# UNITED STATES PATENT AND TRADEMARK OFFICE

<b>Office Action Summary</b>	<b>Application No.</b>	<b>Applicant(s)</b>	
	10/606,110	YOUN, KARP-SIK	
	<b>Examiner</b>	<b>Art Unit</b>	
	Thomas A. Morrison	3653

TITLE: APPARATUS FOR AND METHOD OF PREVENTING PAPER DOUBLE FEEDING IN PRINTER

SERIAL NO.: 10/606,110

FIG. 10

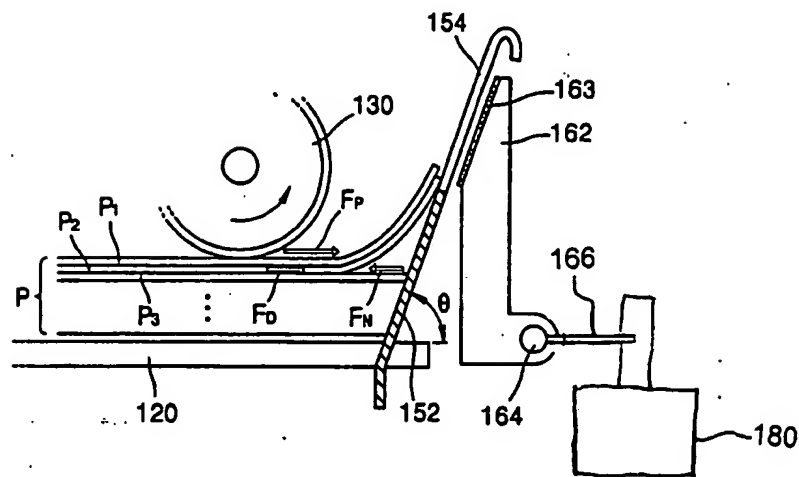
1. The drawings were received on 09/01/2006. These drawings (i.e., newly added Figures 10 and 11) have not been entered, because they introduce new matter. In particular, newly added Figs. 10-11 show details of how a solenoid 180 is arranged and connected to a shaking plate 166, which is not supported by the disclosure of the instant application. Thus, the newly added drawings (i.e., Figs. 10 and 11) have not been entered.

3. The amendment filed 09/01/2006 is objected to under 35 U.S.C. 132(a) because it introduces new matter into the disclosure. 35 U.S.C. 132(a) states that no amendment shall introduce new matter into the disclosure of the invention. The added material which is not supported by the original disclosure is as follows: (1) the amendment to numbered paragraph [0032] describing new Figures 10 and 11; and (2) the amendment to numbered paragraph [0047].

DO NOT ENTER  
Yam 11/13/06

Applicant is required to cancel the new matter in the reply to this Office Action.
